**XCEL ENERGY'S 2018 DISTRIBUTION SYSTEM
HOSTING CAPACITY STUDY**

Docket E002/M-18-684

FRESH ENERGY'S COMMENTS ON XCEL'S 2018 HOSTING CAPACITY STUDY

Figure 3: Xcel Energy DER Interconnection Tools and Processes

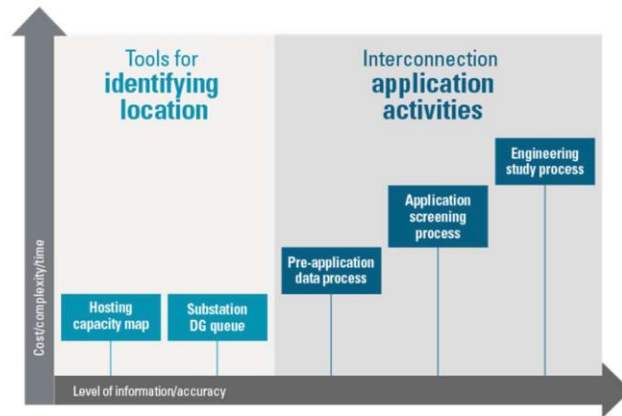
only fully understood after the full engineering study has been performed. Xcel's Figure 3 illustrates that point.¹⁶

If there are irreconcilable “underlying differences” between the HCA and the study results, that’s a red flag.
